Parking & Stormwater Drainage
Plan in
Tisbury, Mass.
Prepared for
Main Street Medicinals, LLC
Scale 1" = 10' January 20, 2022

From: Alex Elvin <elvin@mvcommission.org>
Sent: Thursday, February 17, 2022 6:31 PM
To: Noah Eisendrath
Cc: Josh Silver
Subject: Re: MVC memo - Main St. Medicinals

Existing
Sewer Covers

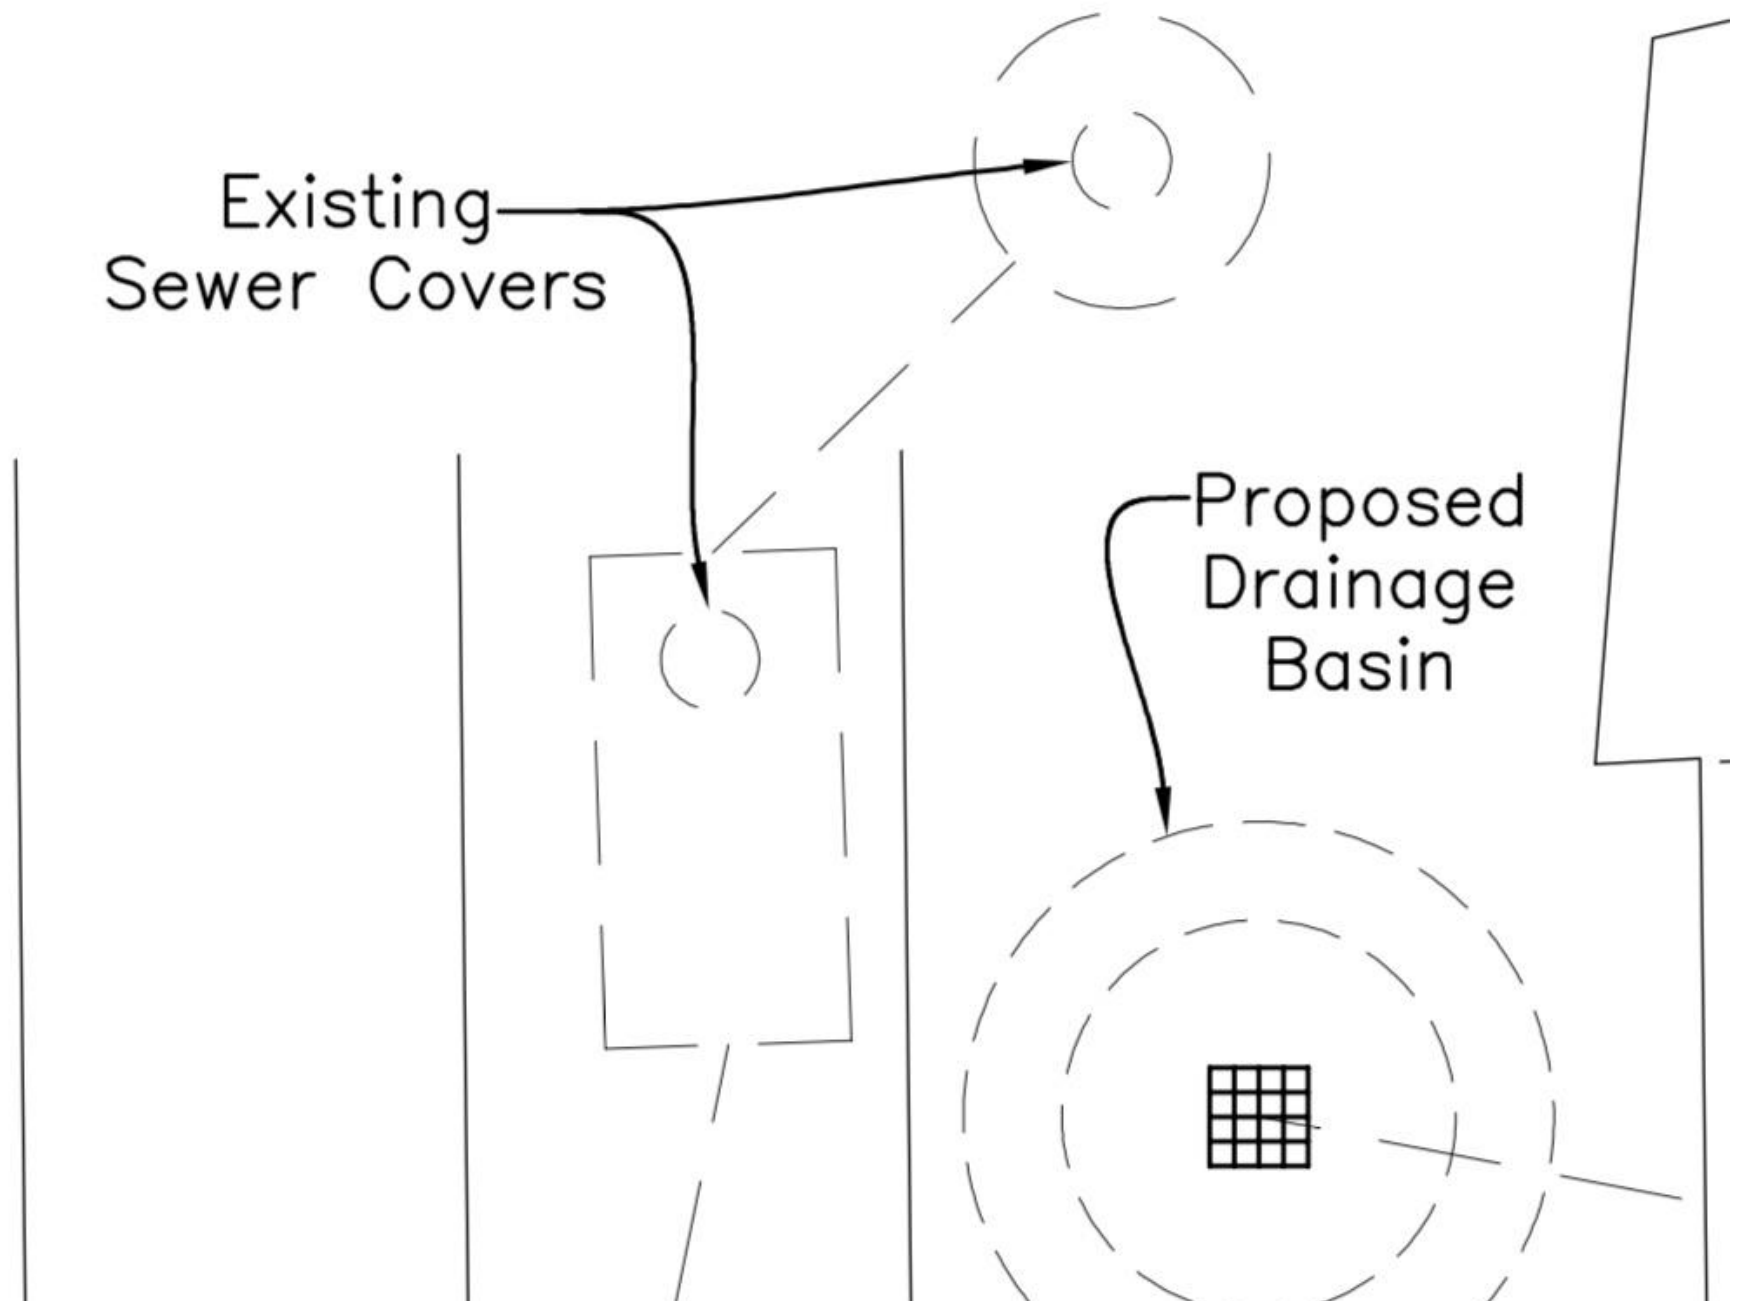
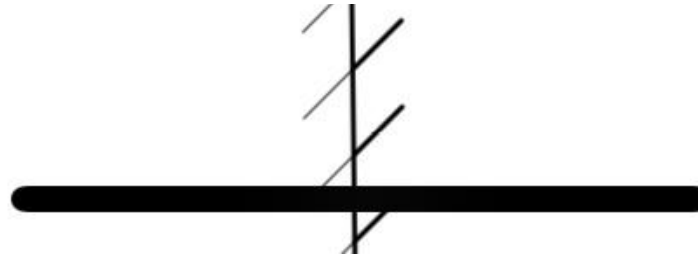
Thanks. Please keep me posted about the septic tank location.

I spoke with Reid, the rectangular box around the existing sewer cover is the septic tanks location. I apologize that these exhibits weren't more clear.
